WINDFALL MINING PROJECT

ADDITIONAL INFORMATION RESPONSES TO QUESTIONS AND COMMENTS - 1ST SERIES

WINDFALL MINING PROJECT –
ENVIRONMENTAL IMPACT
ASSESSMENT
RESPONSES TO QUESTIONS AND
COMMENTS FROM MELCCFP –
1ST SERIE

EEYOU ISTCHEE BAIE-JAMES TERRITORY

Figure RQC1 Summary of the geochemical characterization program carried out on materials from the Windfall project

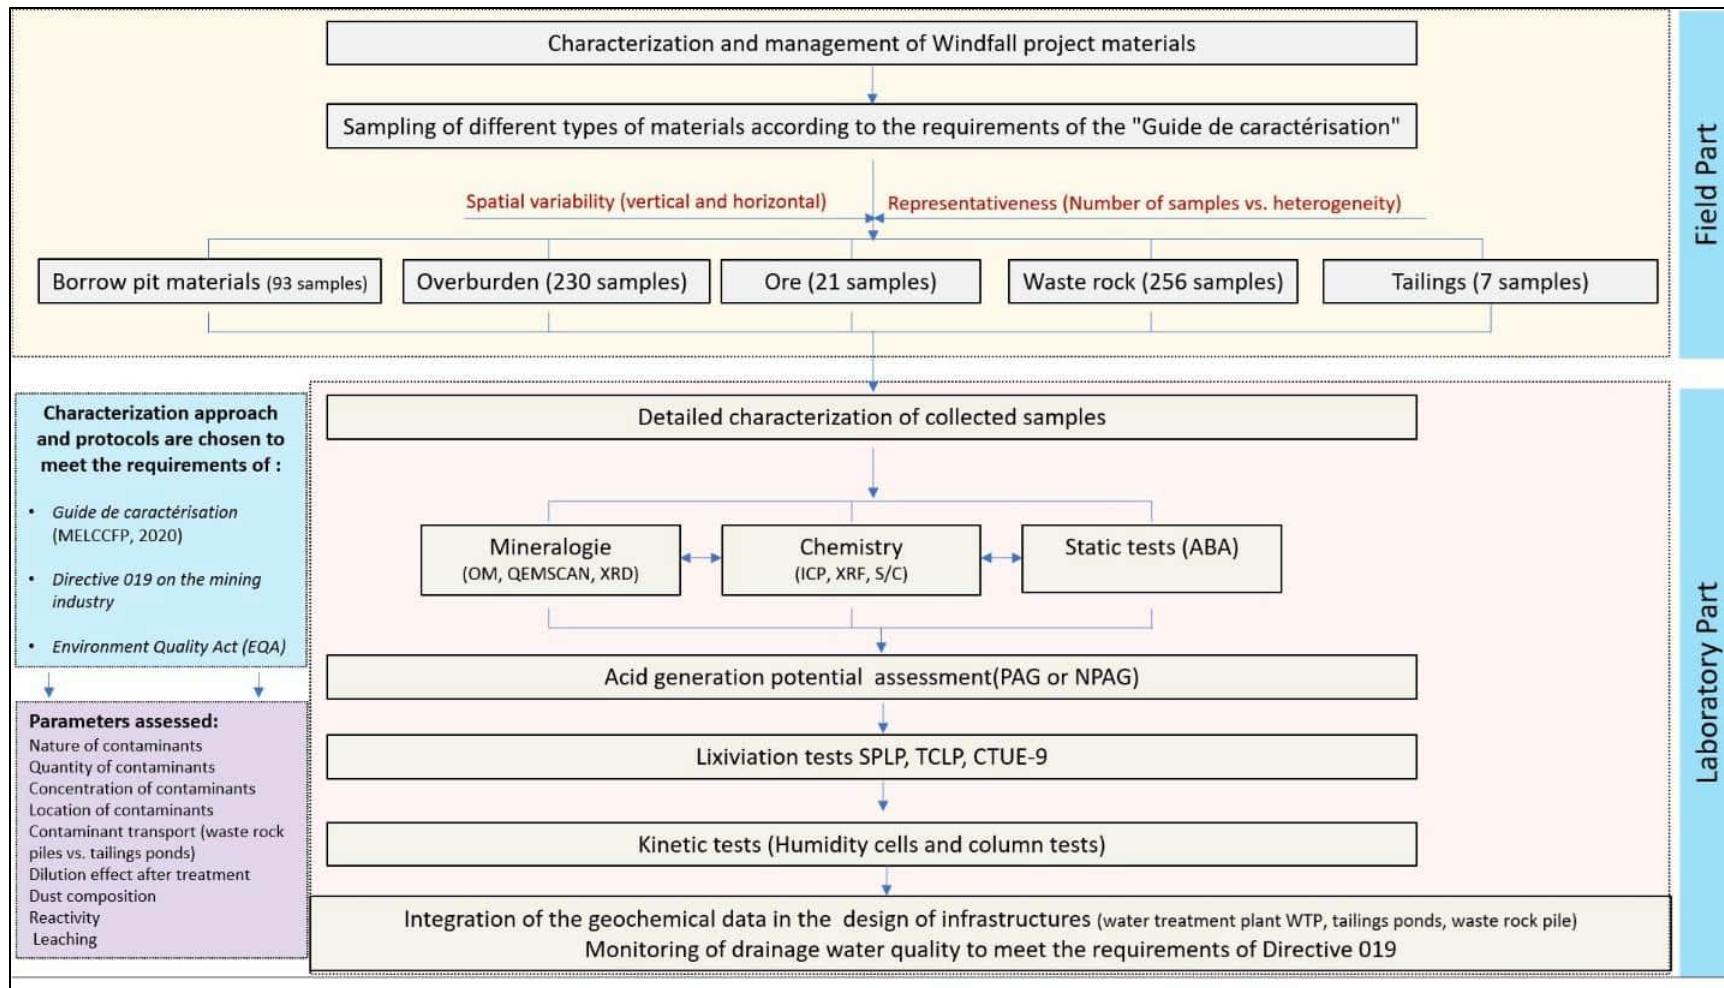
The tailings and ore characterization report only partially meets the requirements of Directive 019 sur l'industrie minière (MDDEP, 2012) (hereinafter referred to as D019) as well as section 23 of the Environment Quality Act (EQA), which specifies that the proponent must provide “the nature, quantity, concentration and location of all contaminants that are likely to be released into the environment” in an application for authorization. In addition, the updated geochemical characterization study of tailings is very sketchy. Considering the acid-generating nature of tailings and the uncertainties concerning the anticipated time before the onset of acid mine drainage (AMD) conditions in the field, the objectives of this follow-up and the characterization program must allow AMD conditions to be properly monitored and corrective action to be taken if necessary. The proponent must review the tailings and ore characterization study, taking into account the recommendations below.

A detailed characterization study was carried out by WSP (Environmental Impact Assessment, Vol. 2, Appendix 3-1) on all Windfall project materials related to the potential for acid mine drainage (AMD) generation and leaching of metals and contaminants, to concisely determine the nature, quantity, concentration, and location of all contaminants likely to be released into the environment. The materials studied are those that will be handled by Windfall project operations, i.e., ore, tailings, waste rock, and overburden, even though these are not requested in the *Guide de caractérisation* (hereinafter the Guide; MELCC, 2020). To meet these objectives, a characterization approach has been designed to classify these materials according to their leaching and acid-generating potential and meet the requirements of the Guide and D019, *Directive 019 sur l'industrie minière* (MDDEP, 2012). This characterization approach consists of two essential parts: the field part and the laboratory part (see Figure RQC1).
